# COMMUNITY DEVELOPMENT DEPARTMENT REPORT

HEARING DATE: 6/5/2025  
TO: Planning & Zoning Commission  
FROM: Nick Napoli, Associate Planner  
208-884-5533  
nnapoli@meridiancity.org  
APPLICANT: Steve Shaw  
SUBJECT: H-2025-0018  
El Pollo Loco

A Conditional Use Permit (CUP) is requested for a 2,000 square foot drive-through establishment within 300 feet of another drive-through and residential district. The site consists of 0.87 acres in the C-G zoning district.

**D. Site Plan (date: 5/24/2025)**

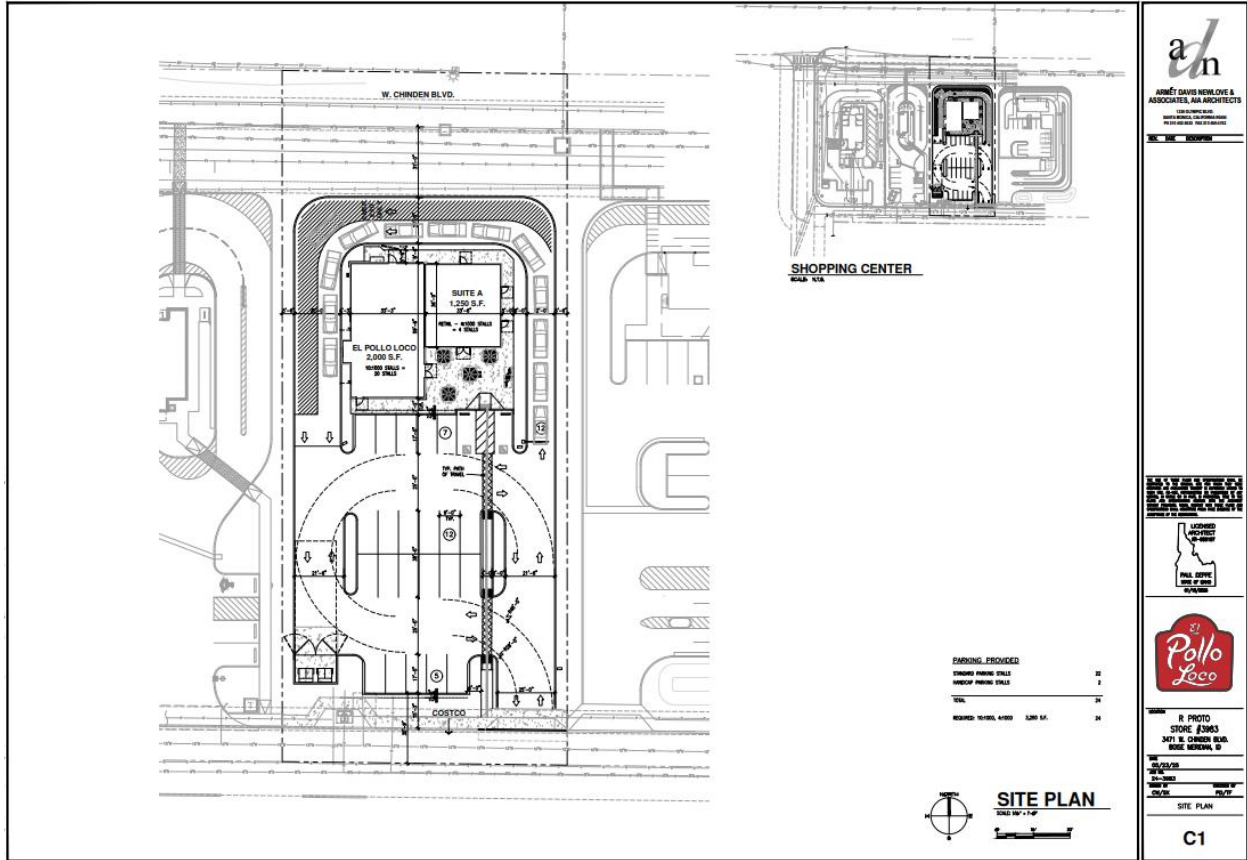
*In order for the outside travel lane to function as an escape lane as required for drive-throughs that exceed 100 feet in length, Staff recommends that no stacking is allowed in this area. Signage should be installed notifying patrons not to block the escape lane.*

*The site plan accommodates queuing for a minimum of eight vehicles before the menu board and twelve vehicles before the pickup window. Based on data provided by El Pollo Loco, this appears to be sufficient. According to the applicant, their Southern California locations serve approximately 325 vehicles per day, typically maintaining a queue of around six vehicles, with occasional peaks of seven to eight vehicles. In anticipation of heightened interest during the initial opening period, staff have discussed traffic management with the applicant and recommended implementing temporary traffic control measures to manage potential surges in demand.*

*The stacking lane is separate from the escape lane and main drive aisles. If the drive-through stacks past the 12-car allotment, it will spill into the main drive aisle but will not impede entering or exiting from the property.*

*The stacking lane is greater than 100 feet from the point of entry to the drive-through window; therefore, the stacking lane exceeds 100' in length and an escape lane is required. An escape lane is depicted on the site plan.*

*The drive-through is located on the west side of the building and is visible from W. Chinden Blvd. and from the drive aisle along the southern boundary of the site for surveillance purposes.*

Extend or improve streets, drive aisles, cross access easements or similar vehicular and pedestrian connections provided from adjacent properties. *The subject property will be accessed from a shared private drive aisle on the southern boundary. Along this southern boundary runs a sidewalk for pedestrian connectivity for the large development. The applicant revised their drawings to provide a pedestrian connection to the building from the sidewalk along the southern drive aisle.*

The proposed plan was revised to include a pedestrian walkway from the Multi-use pathway along W. Chinden Boulevard. Where pedestrian walkways cross vehicular driving surfaces, they're required to be distinguished from the vehicular driving surface through the use of pavers, colored or scored concrete, or bricks as set forth in UDC 11-3A-19B.4. *The site/landscape plan shall be revised to specify the material being used for the connection. If the connection crosses through the drive aisle, it shall be delineated from the driving surface through pavers, colored or scored concrete.*

2. The site plan and/or landscape plan, as applicable, shall be revised with the certificate of zoning compliance application as follows:
  - i. No stacking is allowed in the outside travel lane that serves as an escape lane; depict signage notifying patrons not to block the escape lane.

- ii. Signage shall be installed ahead of the north/south crossing, warning drivers to watch out for pedestrians.
  - iii. Provide details for what material will be used to delineate the pedestrian connections from the drive aisle.

- v. Update the landscape plan to match the site plan.
3. Compliance with the specific use standards listed in UDC 11-4-3-49 and 11-4-3-11 is required.

## E. Landscape Plan (date: 4/24/2025)

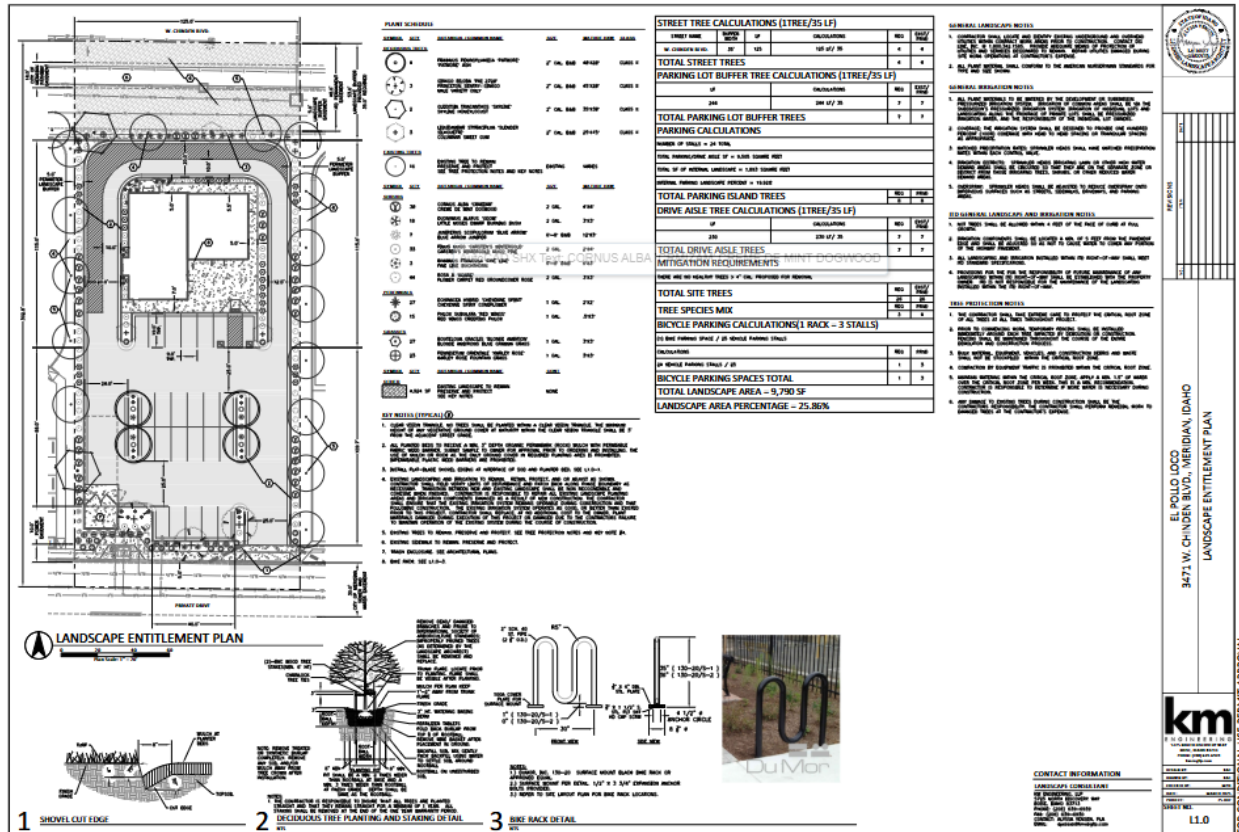
Landscaping is required to be provided along all parking areas per the standards listed in UDC 11-3B-8. *The proposed landscape plan appears to meet the minimum requirements. The applicant shall provide vegetation coverage calculations with the submittal of the certificate of zoning compliance submittal.*

*The applicant shall preserve and protect the existing trees in the neighboring properties landscaping buffers. If trees are proposed to be removed, the applicant shall provide mitigation calculations with submittal of the certificate of zoning compliance application.*
